4745 40th Ave SW

Second Early Design Guidance
DPD# 3014877

Second Early Design Guidance

The Design Review Board first reviewed this project on May 23, 2013. In response to concerns of the Board, a second Early Design Guidance Meeting was requested.

Streetscape Concept Plan from West Seattle Triangle Planning study.

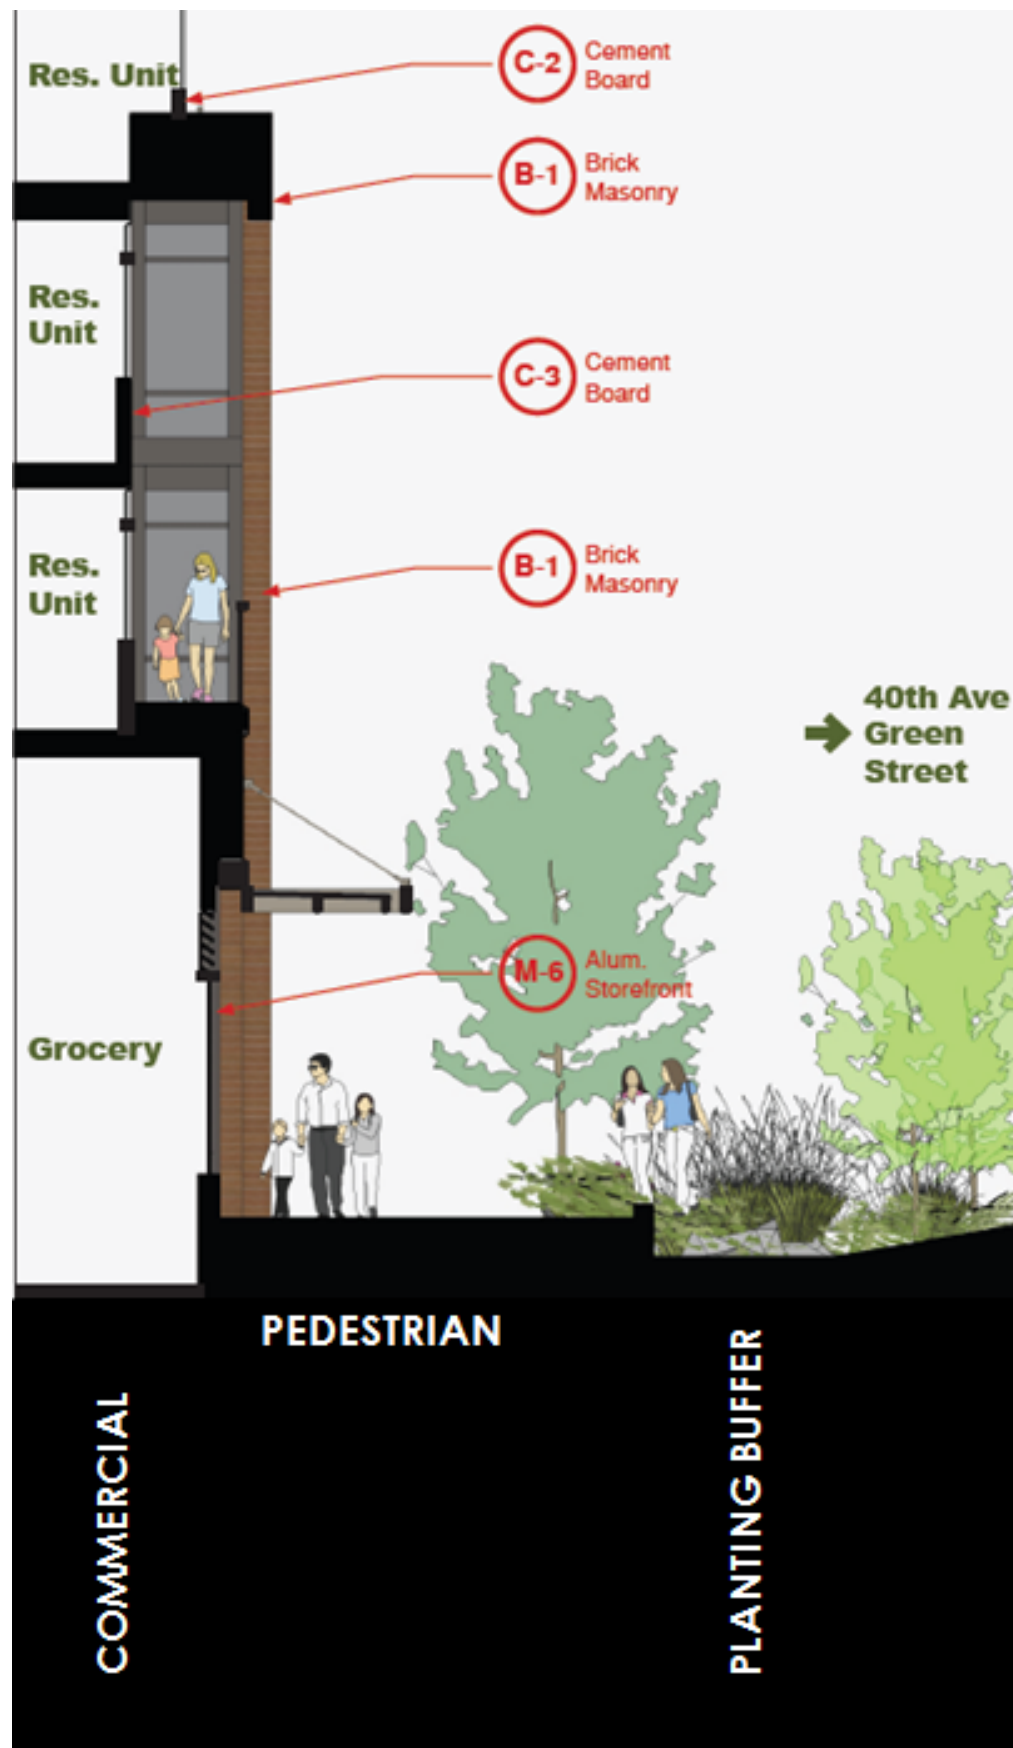
Evidence of how the proposal connects with other projects (namely the Whole Foods site) across 40th Ave. SW needs further explication. Provide a schematic or concept landscape plan along the frontage for the next EDG meeting. The wide planting strip on 40th Ave SW warrants a creative landscape design that complements the design for the Whole Foods mixed use project.

The pedestrian nature of 40th Ave is enhanced in the proposed design. The plaza landscaping in front of the Whole Foods Project is emulated in the design of the wide planter strip in front of the project, while acknowledging the transition from the larger commercial scale to the north, and the smaller residential scale to the south. The main entry to the Whole Foods will activate the northern street front, and the smaller scale entries and patios will activate the southern street front.

The entry plaza to the project will create a connector between the future park and the landscaped planting and gathering space to the south.

Live/work units provide a transition between the large scale commercial and the smaller scale residential.

Study 3

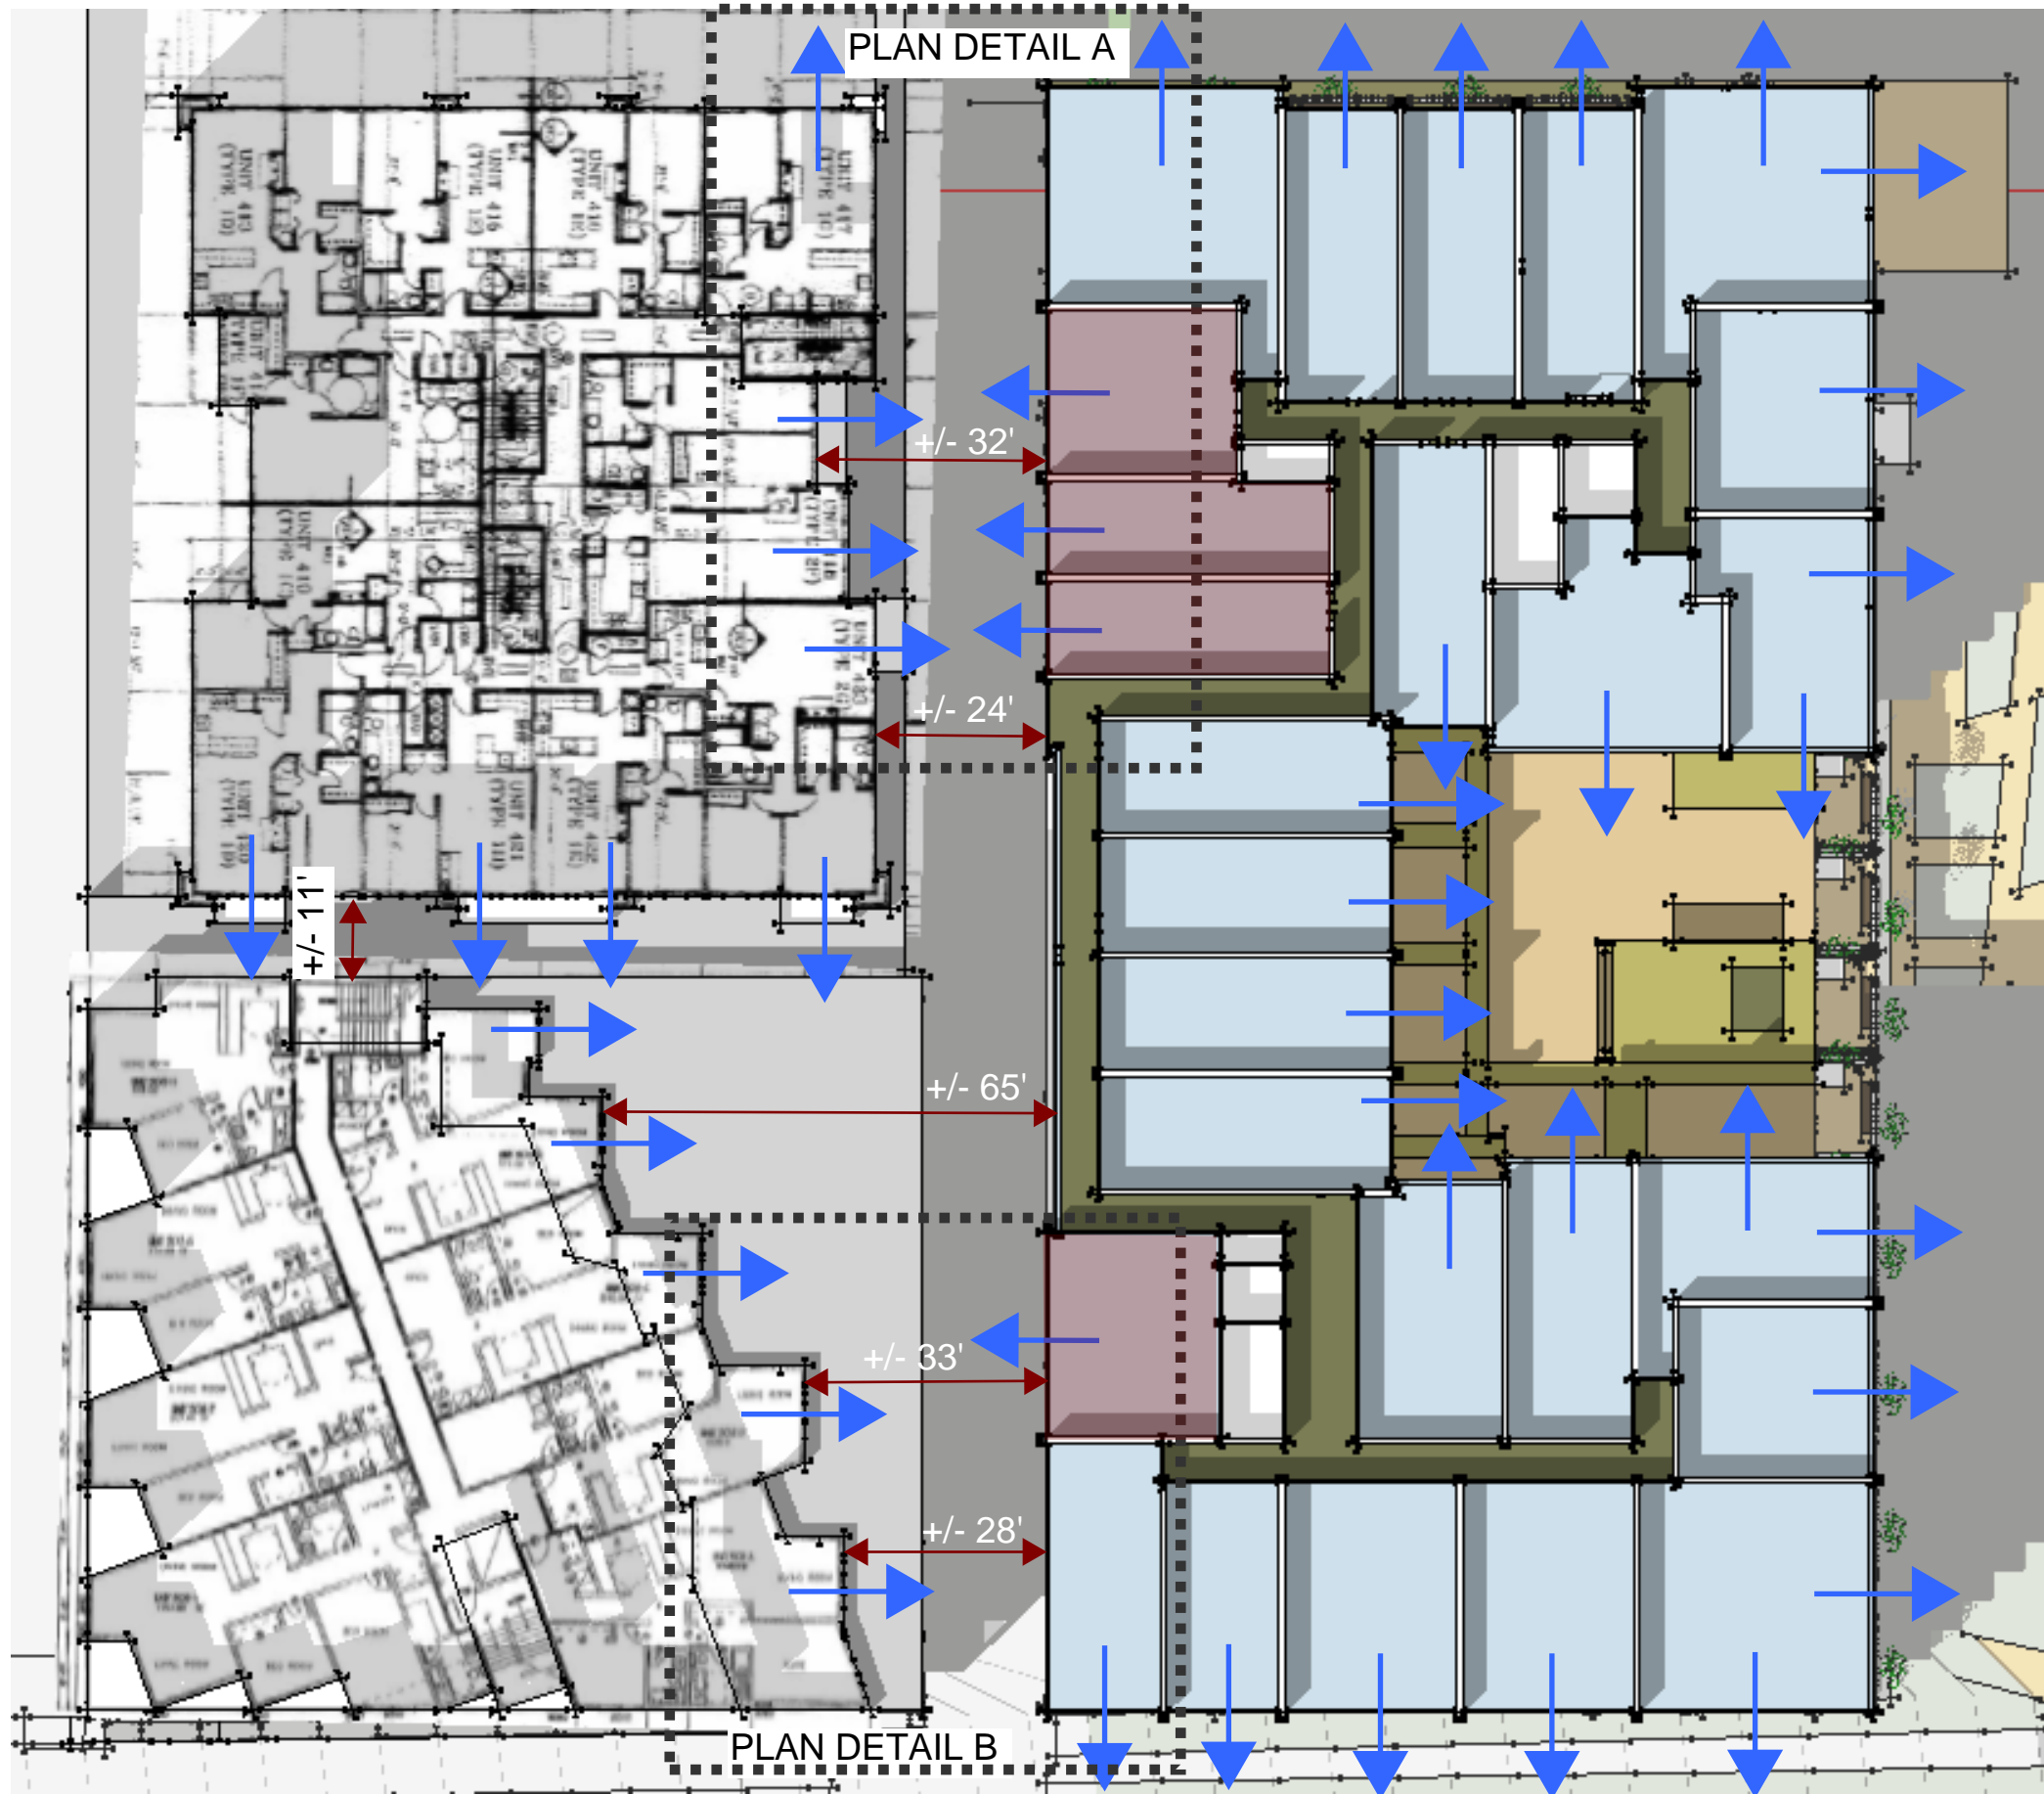
The Board noted the proposal's lack of recognition of the residential structures across the alley. The architect should step the structure back from the alley or sculpt its west facade in deference to the neighboring structures.

In Study 3, the entire west side is setback approximately 5' from the alley.

This provides for incrementally more separation at our closest proximity to the neighboring buildings, however, the decreased width results in the loss of four units per floor. The north and south wings would be slightly decreased in width to stay within the allowable FAR. In order to meet the target density established in the recent West Seattle Triangle planning study, an additional story is added to the entire building. This results in the same number of units as proposed in the preferred scheme.

Detail Plan A

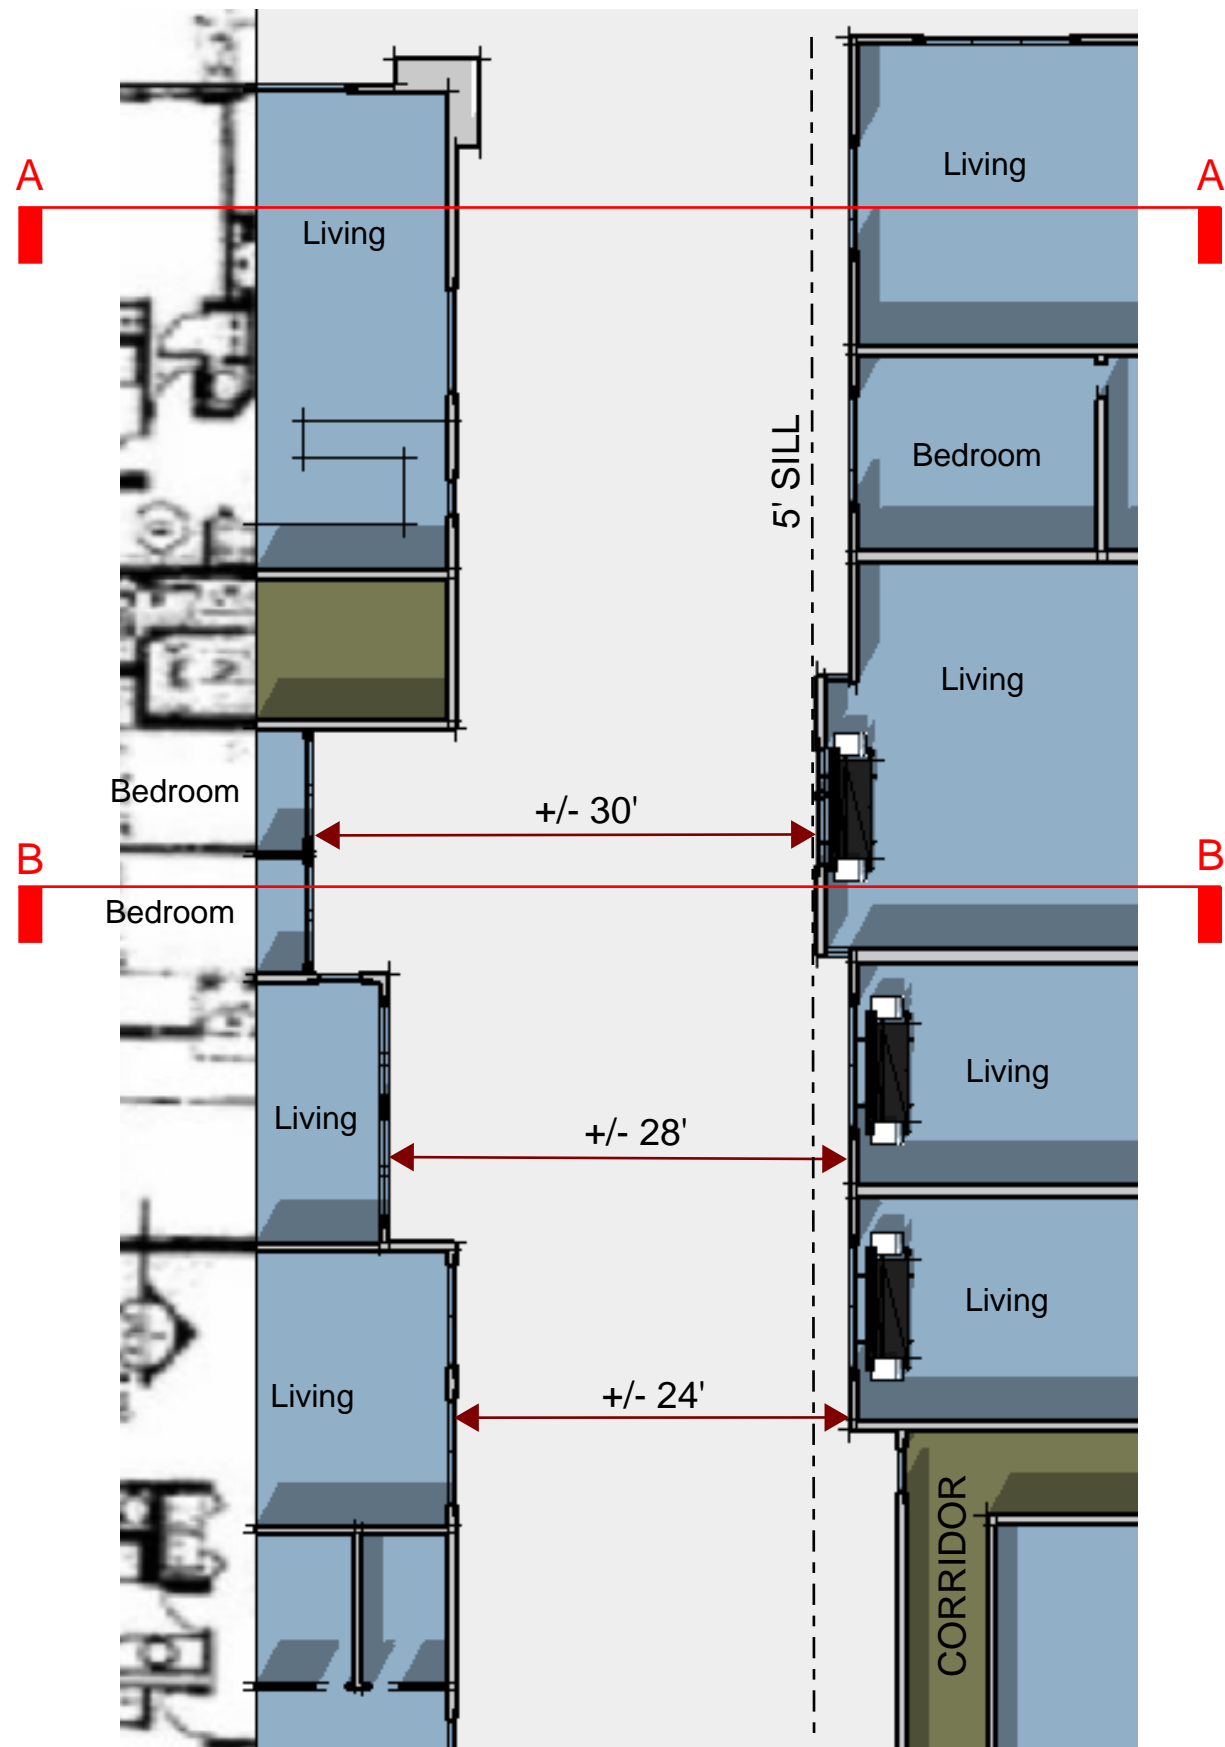
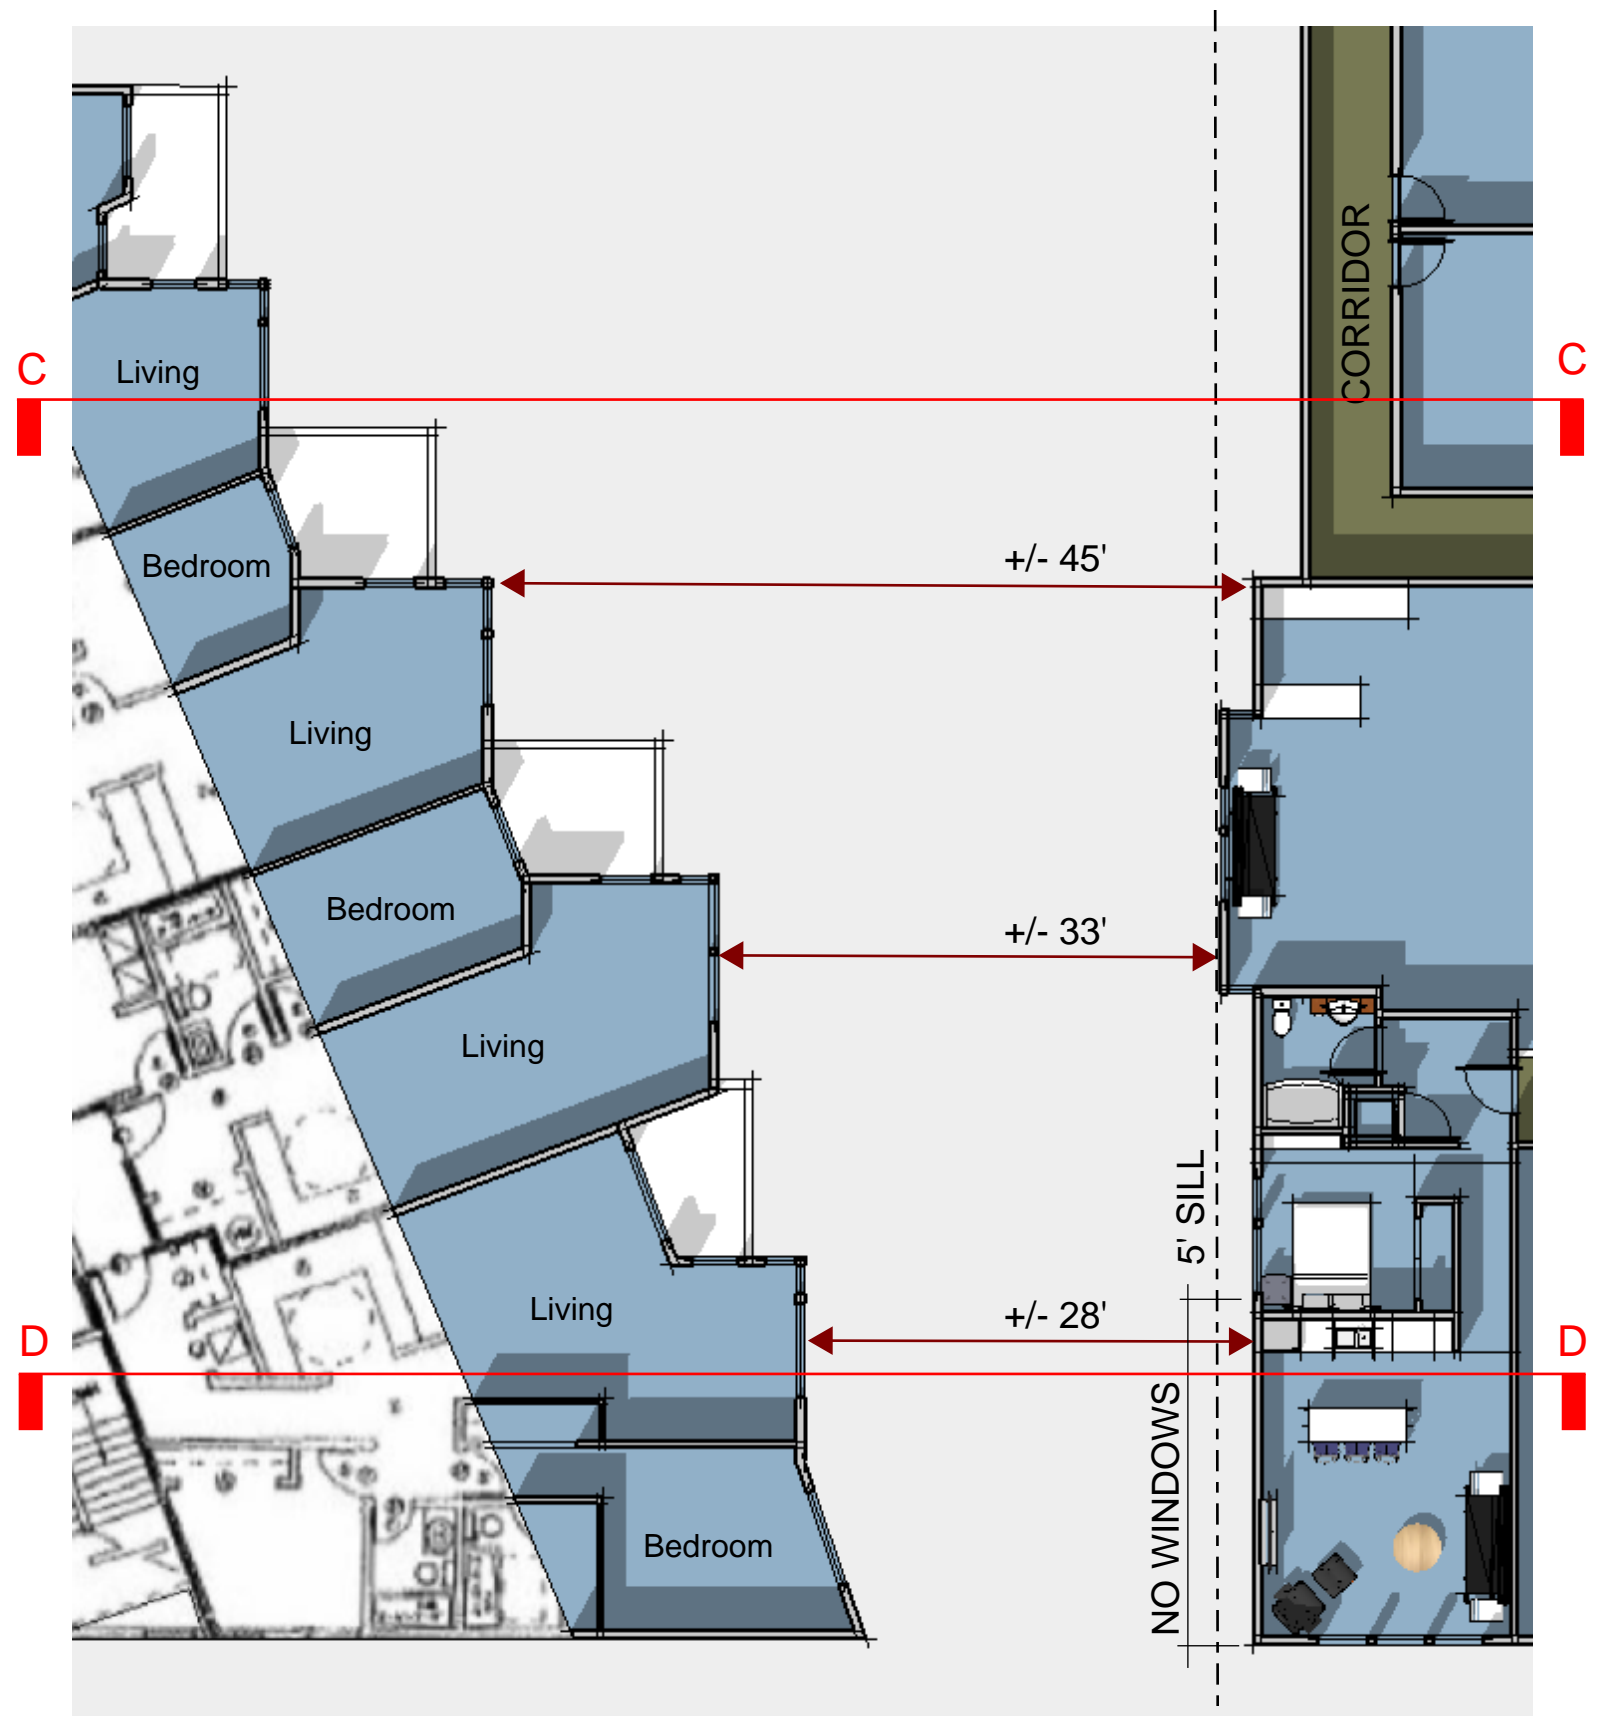
See guidance for B-1. The proposed structure should acknowledge the buildings across the alley with a larger setback or with the use of terraces.

Most of the proposed units are oriented away from neighboring units to maintain the privacy of neighbors. The single loaded corridor in the central portion helps to limit the windows facing west.

Where units do face each other, careful window placement is considered to limit views across the alley. See detail plans on following sheet.

Higher window sills are used at bedrooms on the west elevation to limit direct views.
